WMATA – EGR Vent Line P-Clamp Repacement

Property and TopBus Number:
WMATA 325000 & 325500 – 8001 thru 8105.

Issue: EGR Vent Line P-Clamps

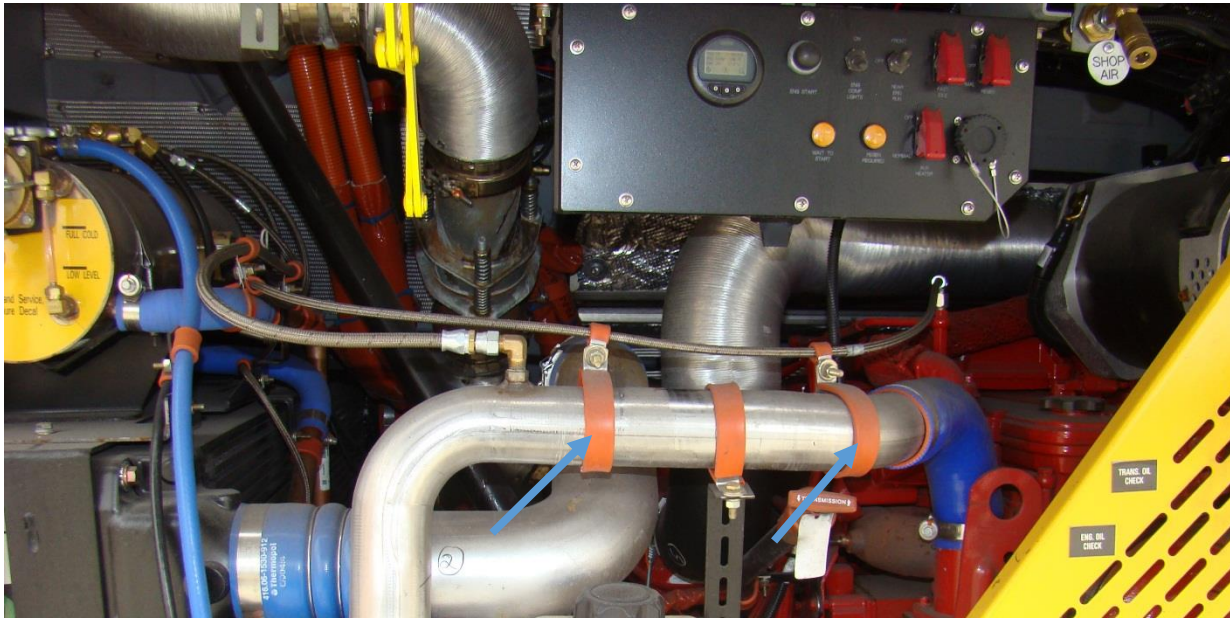
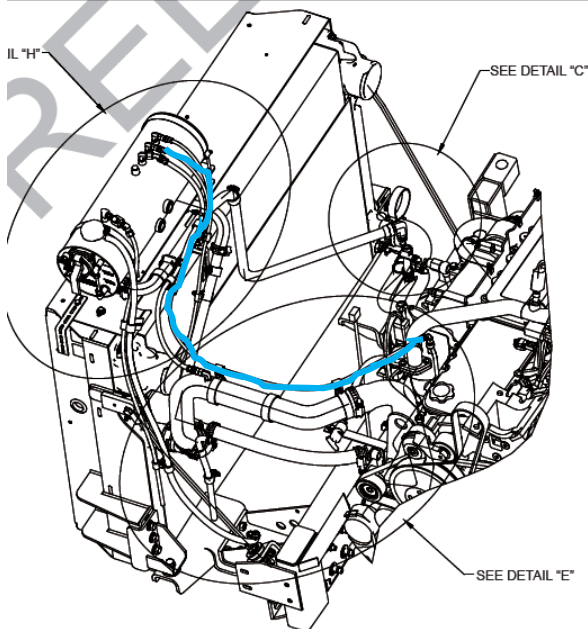
1. Park the bus on level surface and apply parking brake. Turn engine off.
2. Open the rear engine door.
3. Locate & remove the two p-clamps that fasten the EGR vent line to the coolant pipe (see below). Discard existing p-clamps, hardware to be reused in step 4.

4. Install two new p-clamps NABI PN: 42D-1315-007 to the coolant pipe using the hardware removed in step 3 & tighten the hardware securely (see below). **It is very important that these clamps are orientated exactly as shown. The vent line must continuously elevate to the surge tank to avoid any traps in the line.**
